**From:** Sami Malaeb [s.malaeb@comcast.net]  
**Sent:** Friday, February 14, 2014 5:00 PM  
**To:** Detterman, Mark, Env. Health; britpete@aol.com  
**Cc:** Roe, Dilan, Env. Health; LGRIFFIN@OAKLANDNET.COM; rbatiste@eec-corp.com  
**Subject:** RE: Chevron 98861 (Independent); 2145 35th Avenue, Oakland, (RO2945)  
**Attachments:** Figure 1 Future Site Plan.pdf; Figure 2 Future Site Plan and Depiction of TPHG and TPHD in Soi (02.14.14)l.TCT.pdf

Alameda County Environmental Health (ACEH) staff has reviewed the case file for the above referenced site including the *Soil and Groundwater Investigation Report*, dated November 12, 2013, (received November 25, 2013), and the *Semi-Annual Groundwater Monitoring Report, Fifth Sampling Event, December 2013*, dated December 23, 2013. The reports were prepared and submitted on your behalf by Eagle Environmental Construction (EEC). Thank you for submitting the reports. The investigation report documented the installation of soil bores BH-16 to BH-25 that appear to have defined the downgradient and lateral extent of the soil and groundwater plume, and evaluated the site against the Low-Threat Closure Policy (LTCP). The report found that the site

FIGURE 4  
 FEBRUARY 2014

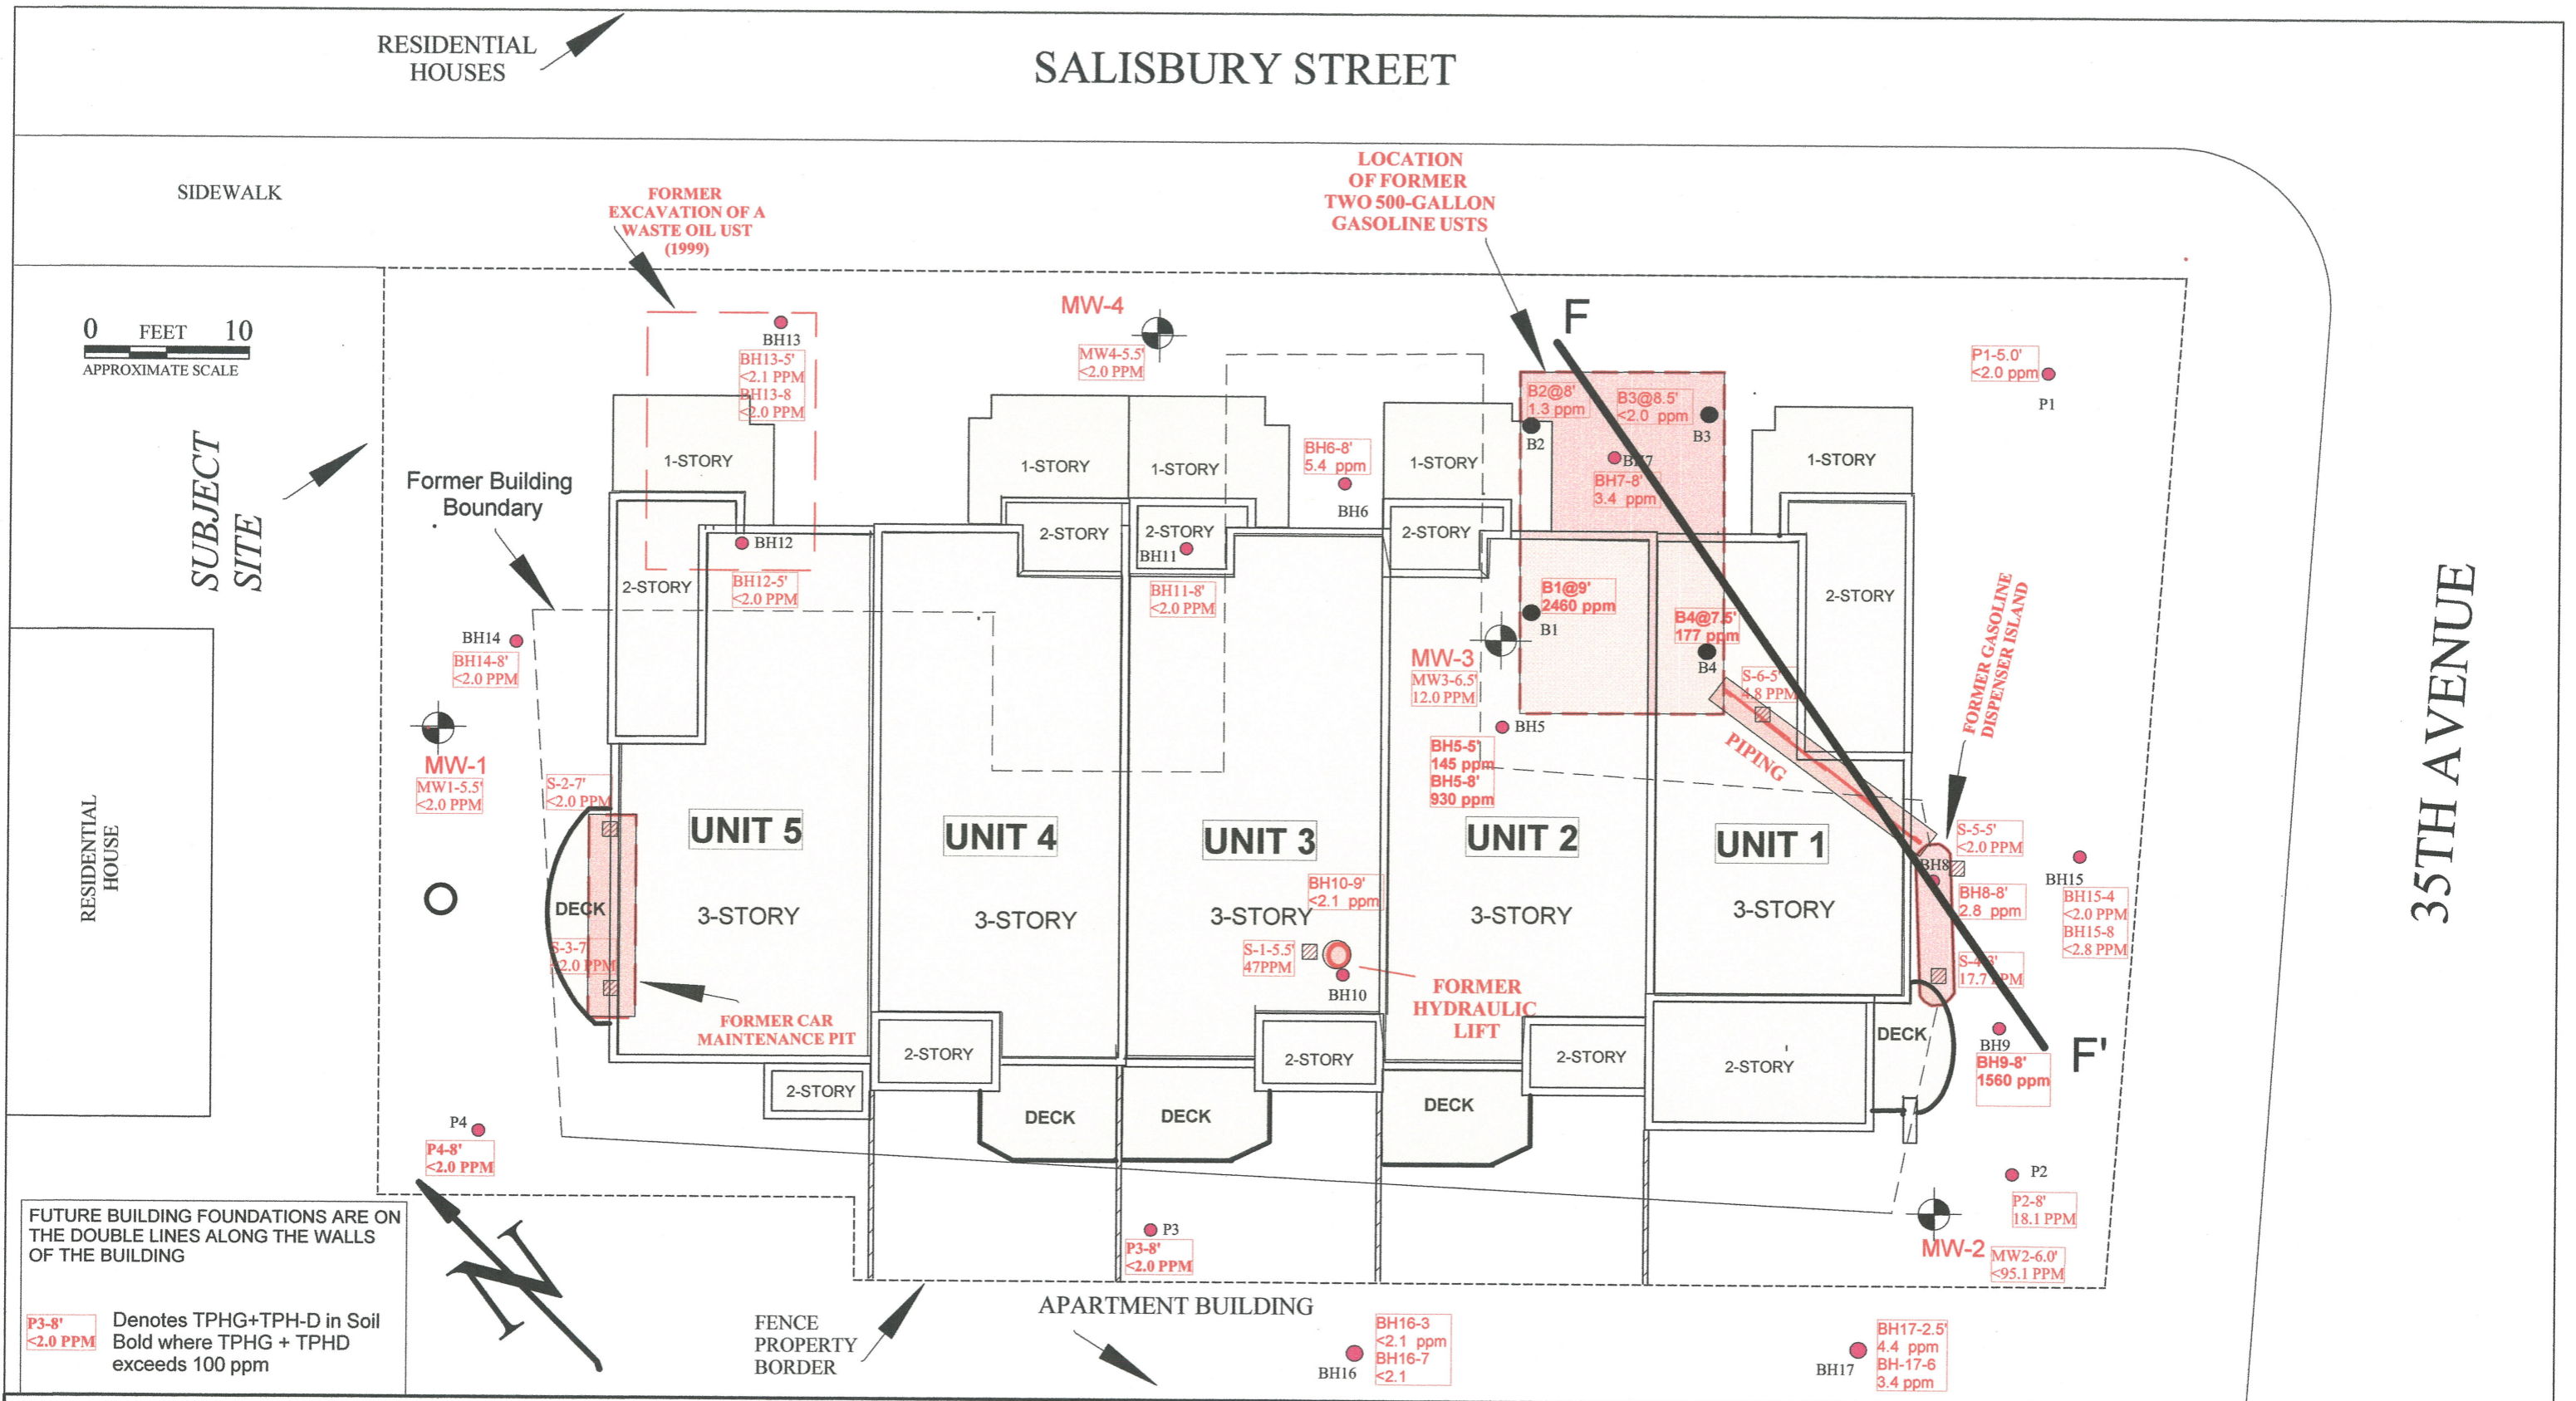
- b. Additional Site Figures** – Prior to the requested meeting, ACEH requests the submittal of a figure that depicts the location of the future residential building features on to a figure that also depicts former site use areas, and site soil bores, wells, and etc. in order to help facilitate an understanding of the juxtapositioning of past and future uses of the site, and identification of areas of potential concern. ACEH also requests a site plan figure depicting the foundation trench excavation plan overlain on to former use areas, and site soil bores, wells, and etc. ACEH also requests a cross-sectional figure depicting proposed building excavation areas (foundation trench, elevator, or other excavation) overlain on former use areas, and soil or well bore analytical data (especially soil data). Finally, the generation of a conceptual Proposed Soil Excavation Areas figure will also be of assistance in this process.

Figure 4 - Shows the cross section location.
